TYPICAL SECTIONS
MOANALUA FREEWAY
REPLACE GLARESCREENS AND GUARDRAILS
FEDERAL AID PROJECT NO. STP-H201(2)
INTERSTATE ROUTE H-1
REPLACE GLARESCREENS
FEDERAL AID PROJECT NO. IM-H1-1(231)
Scale: As Shown Date: Nov. 1997
SHEET No. 1 OF 3 SHEETS

STATE OF HAWAII
DEPARTMENT OF TRANSPORTATION
HIGHWAYS DIVISION
TYPICAL SECTIONS & DETAIL
CONCRETE GLARE SCREEN UPGRADE DETAILS
MOANALUA FRWY. REPLACE GLARE SCREENS & GUARDRAILS
Alaia Interchange To Moanalua Stream Bridge
F.A. Proj. No. STP-H20(2) AND
INTERSTATE ROUTE H-1 REPLACE GLARE SCREENS
Alaia Heights Drive To Salt Lake Boulevard
F.A. Proj. No. 1M-HI-1(231)
Scale: As Noted Date: Nov. 1997

STATE OF HAWAII DEPARTMENT OF TRANSPORTATION HIGHWAYS DIVISION	
TYPICAL SECTIONS & DETAIL	
WORK ZONE CONSTRUCTION PLAN	
MOANALUA FRWY. REPLACE GLARE SCREENS & GUARDRAILS Aiea Interchange To Moanalua Stream Bridge F.A. Proj. No. STP-H20(2) AND	
INTERSTATE ROUTE H-1, REPLACE GLARE SCREENS Aiea Heights Drive To Salt Lake Boulevard F.A. Proj. No. 1M-HI-1(231)	
Scale: As Noted	Date: Nov. 1997
SHEET No. 3 OF 3 SHEETS

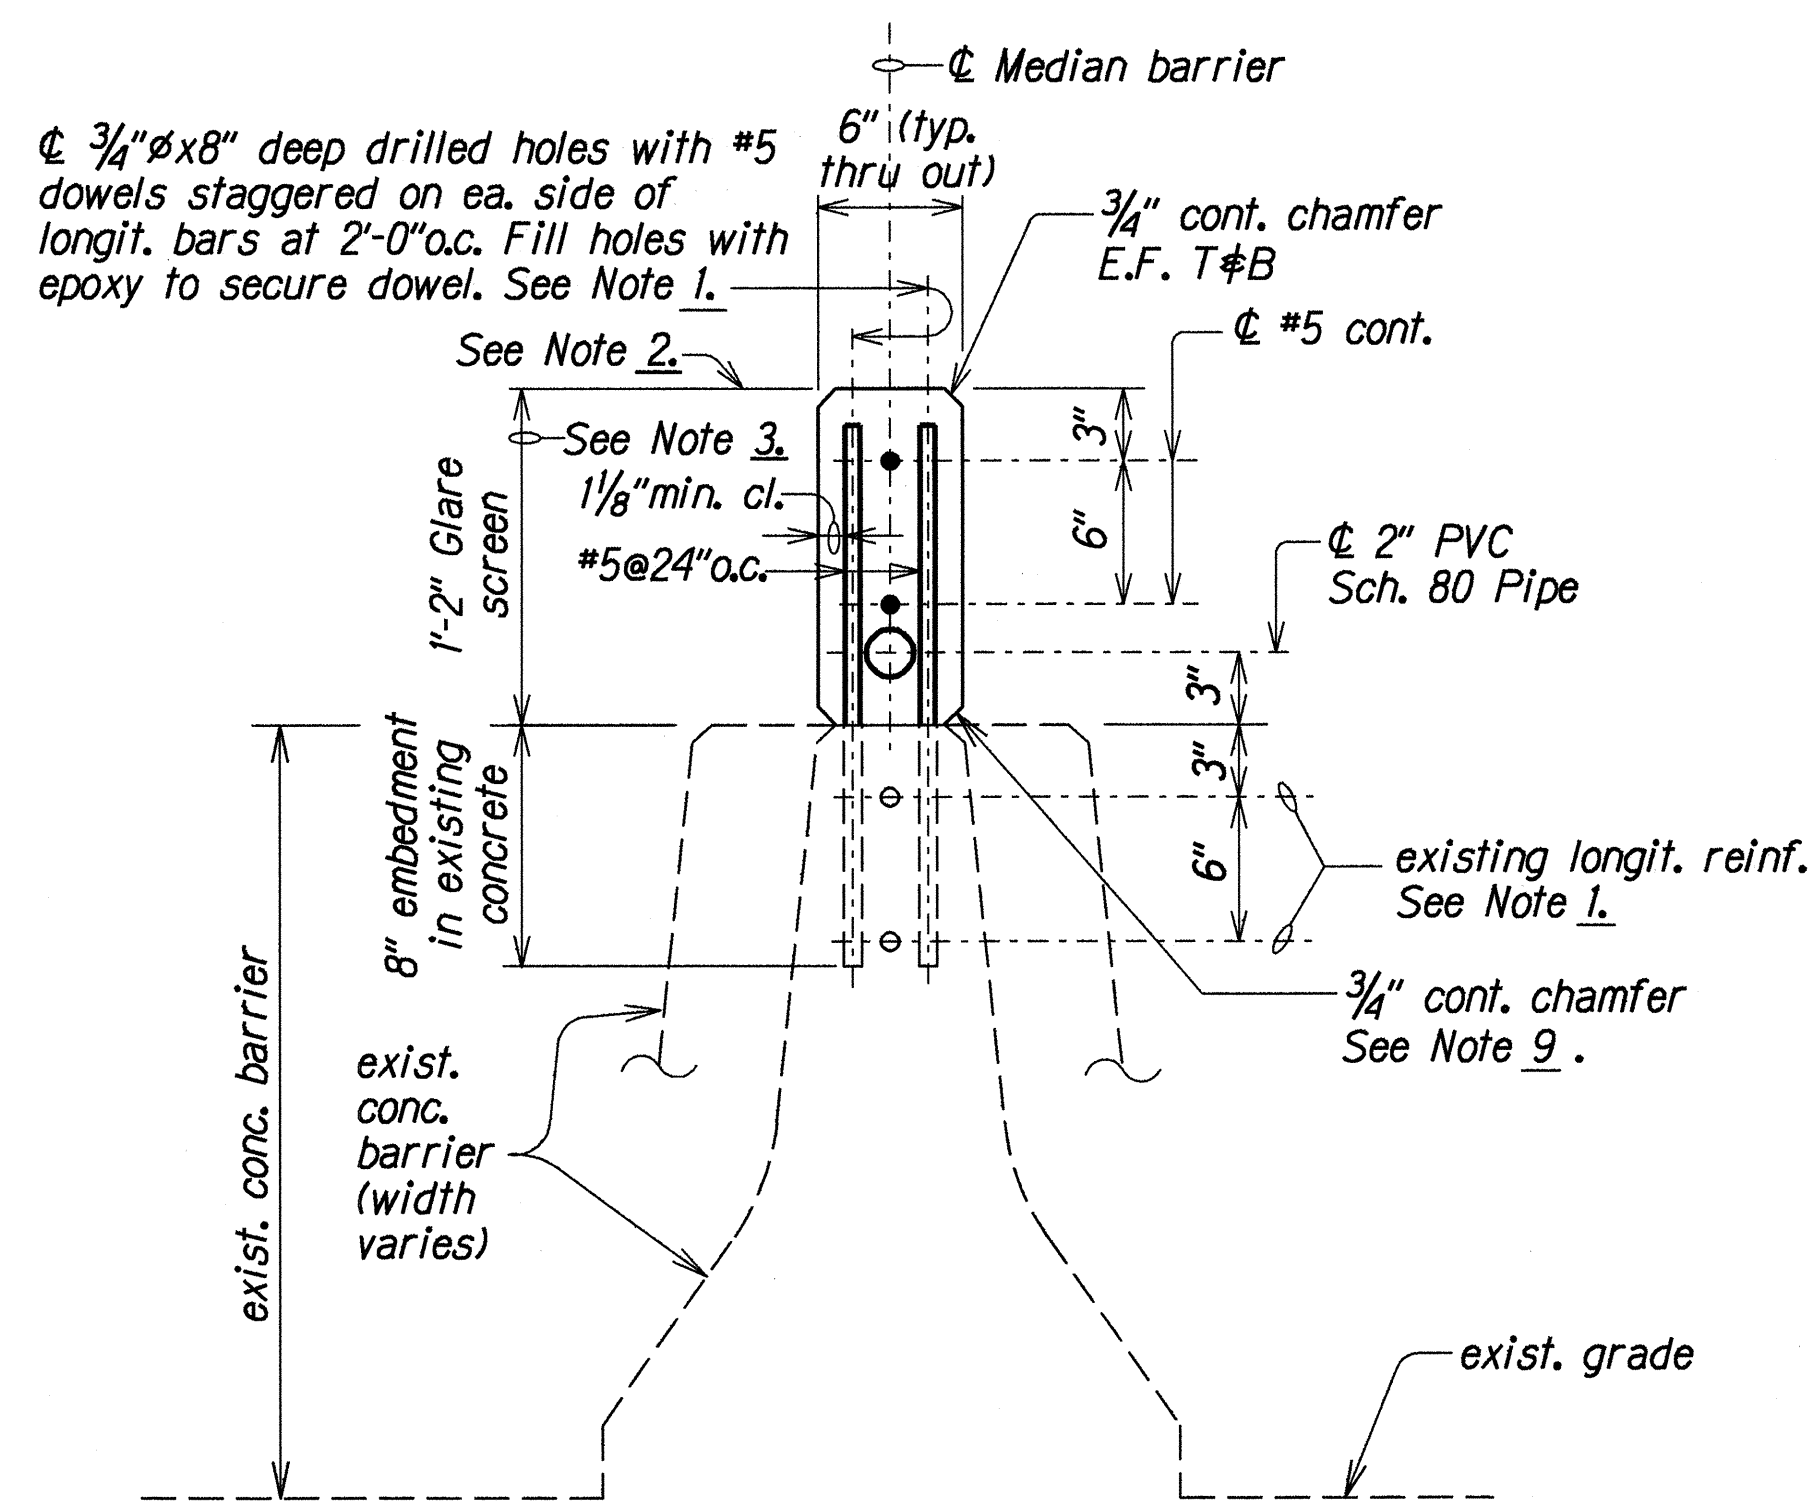
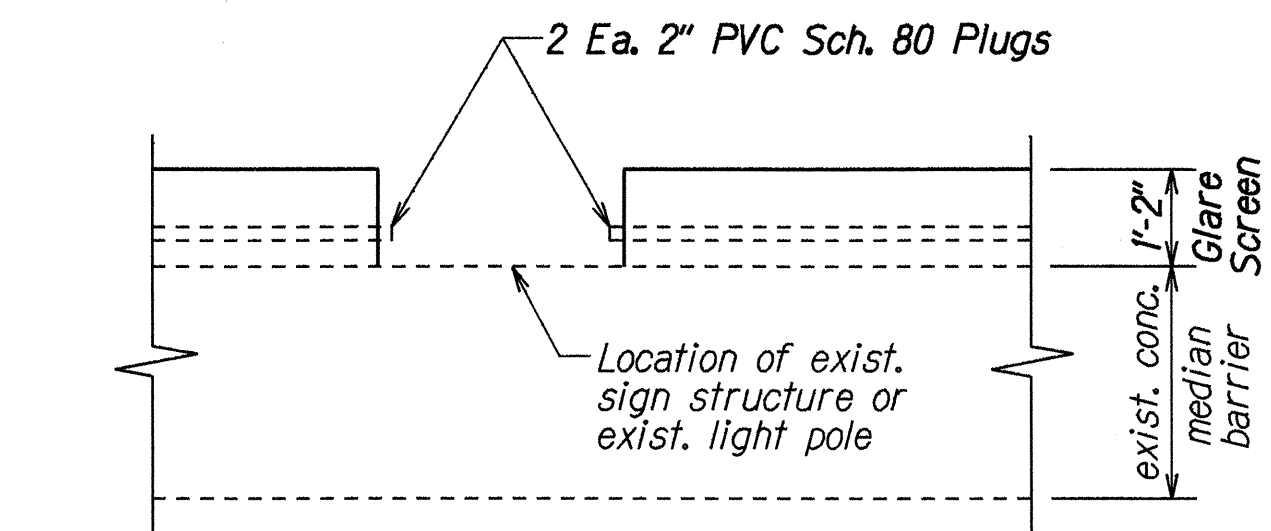
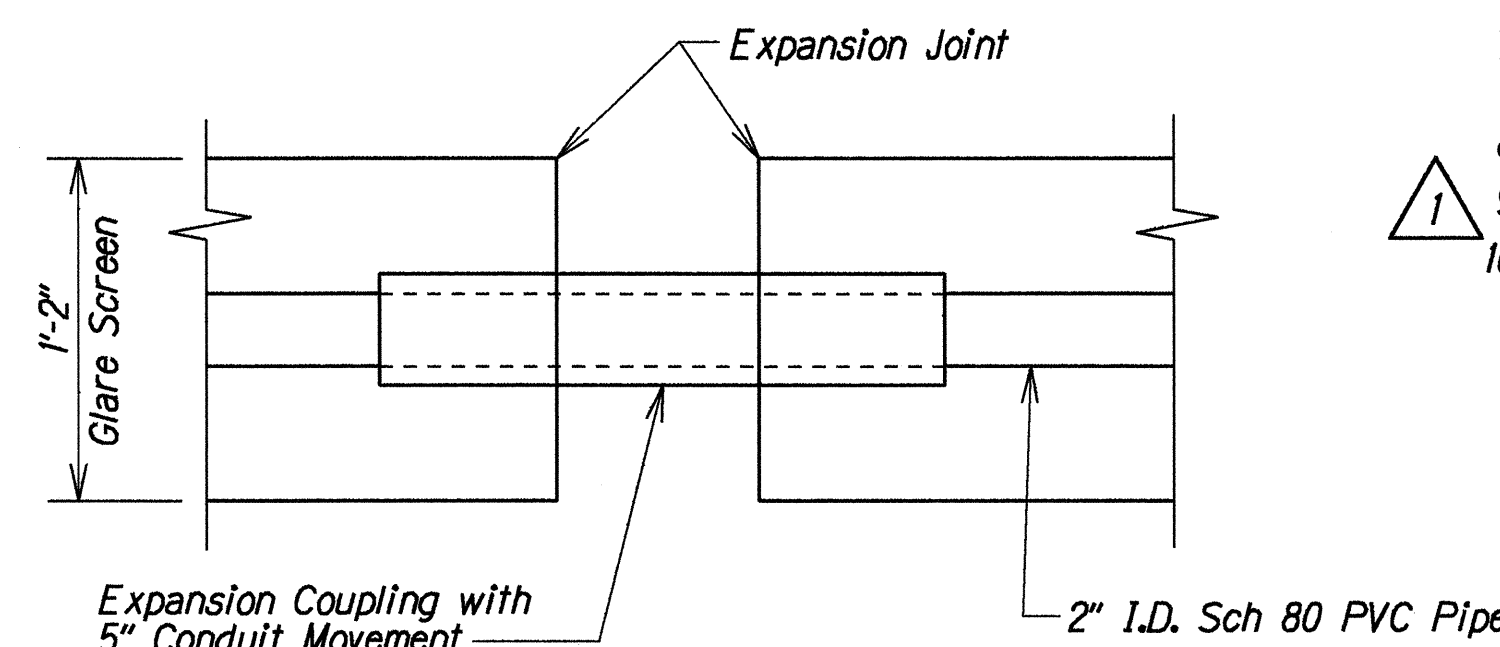
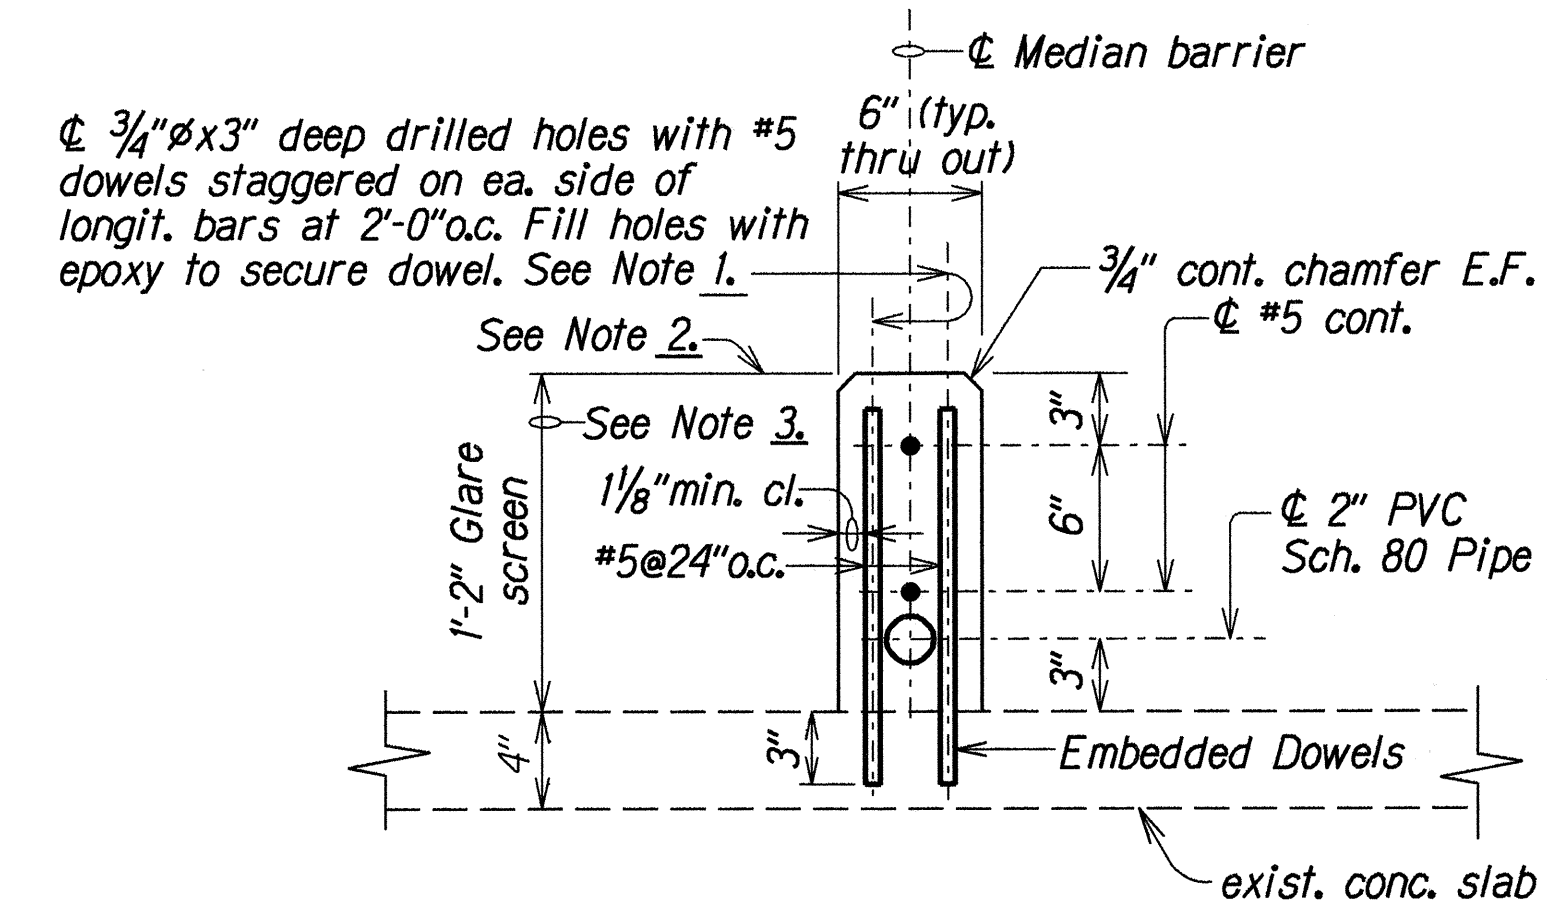
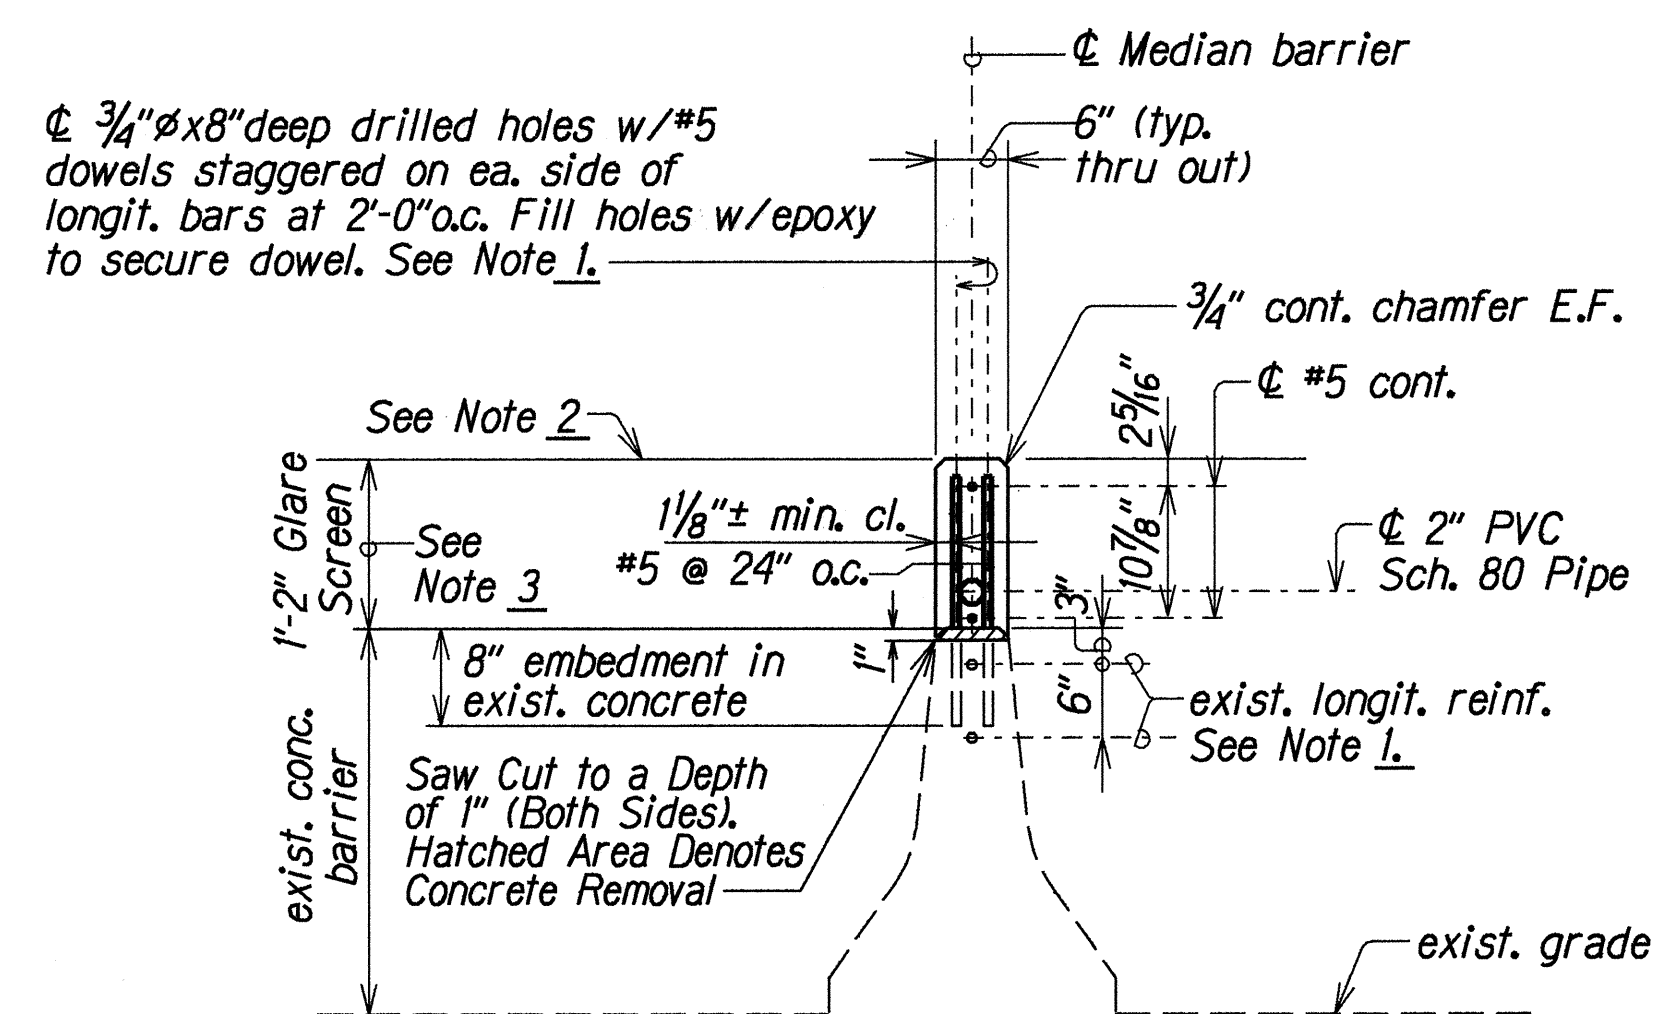
Added 2" PVC Sch. 80 Pipe and changed 2" I.D. galvanized pipe to 2" PVC Sch. 80 pipe in median barrier. Removed "T#B" from Type "A" Median Barrier Upgrade det. for 3/4" cont. chamfer E.F. Labels, dimensions, & dim. lines changed &/or moved for clarity. Added "width" to Note #9. Added PVC Plug and Expansion Coupling Sections.
